NEW BEDFORD WATER WORKS

APPLICATION FOR SERVICE AND METER

952 Peckham Rd (SS) 460' +/- EX ACUSHNET AVE

CITY OF NEW BEDFORD
INSPECTIONAL SERVICES
APPLICATION FOR BUILDING PERMIT
DEPARTMENT/COMMISSION REVIEW

Service #33630

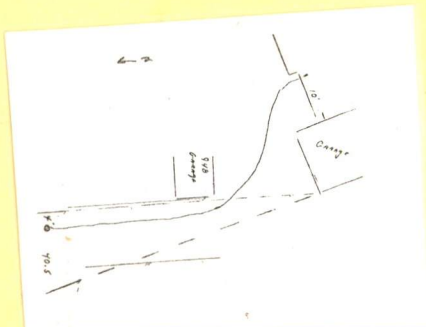
Note: Service runs 9.5 ft W x W line of
#948 Peckham Rd. Garage
